Subject: Sensitive Area Designation for Lake Wisconsin

SENSITIVE AREA DESIGNATIONS

February 18, 2002

Okee Bay Sensitive Area: Red Line is the Revision and Blue Line existing

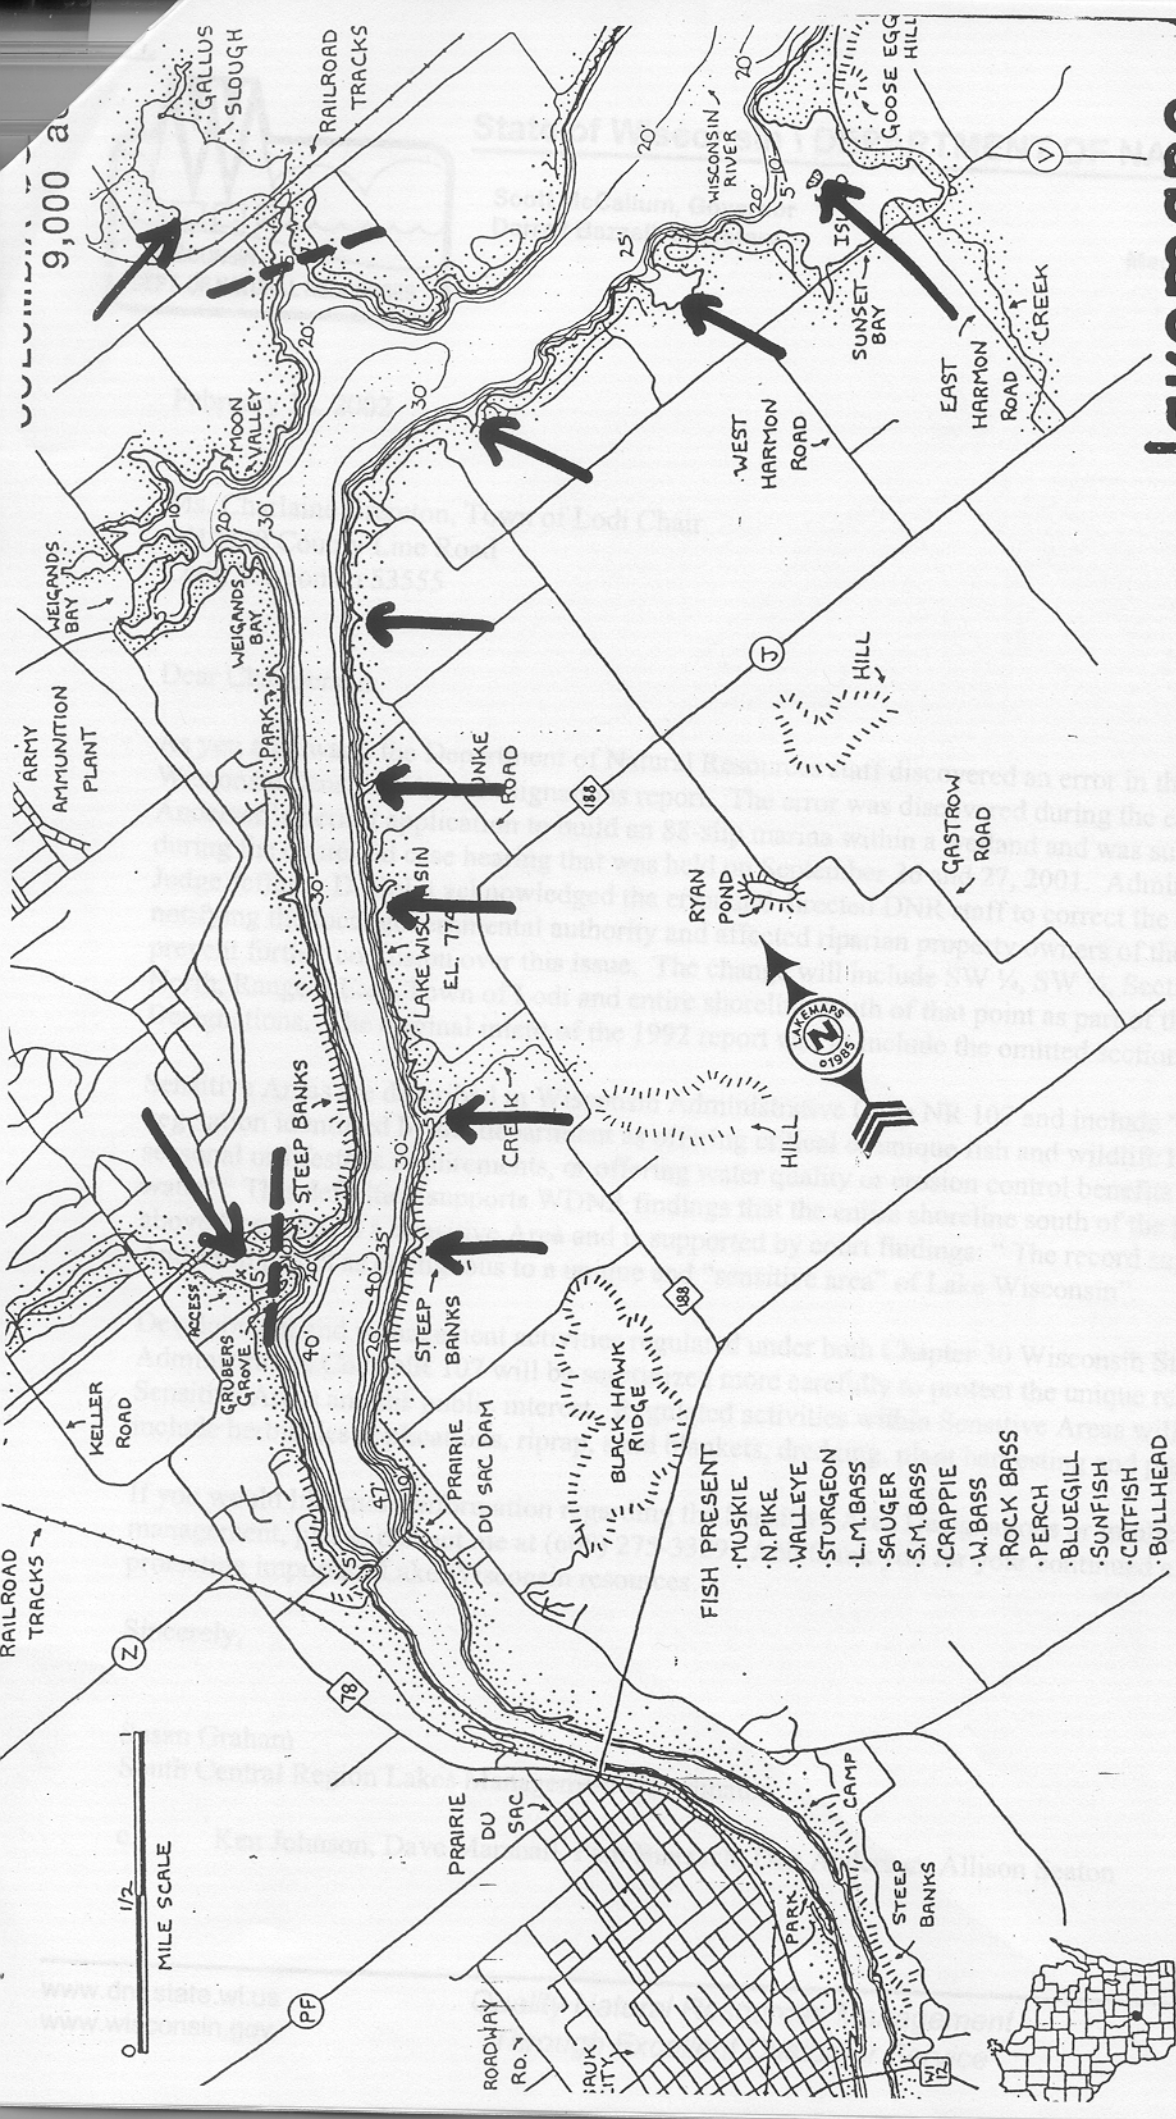
As you are aware, the Department of Natural Resources staff discovered an error in the 1992 Lake Wisconsin Sensitive Area Designations report. The error was discovered during the evaluation of Don Anderson's permit application to build an 88-slip marina within a wetland and was submitted as evidence during the contested case hearing that was held on September 26 and 27, 2001. Administrative Law Judge Jefferey D. Boldt acknowledged the error and directed DNR staff to correct the mistake by notifying the local governmental authority and affected riparian property owners of the change in order to prevent further confusion over this issue. The change will include SW 1/4, SW 1/4, Section 8, Township 10 North, Range 8 East, Town of Lodi and entire shoreline south of that point as part of the Sensitive Area Designations. The original intent of the 1992 report was to include the omitted section of Okee Bay.
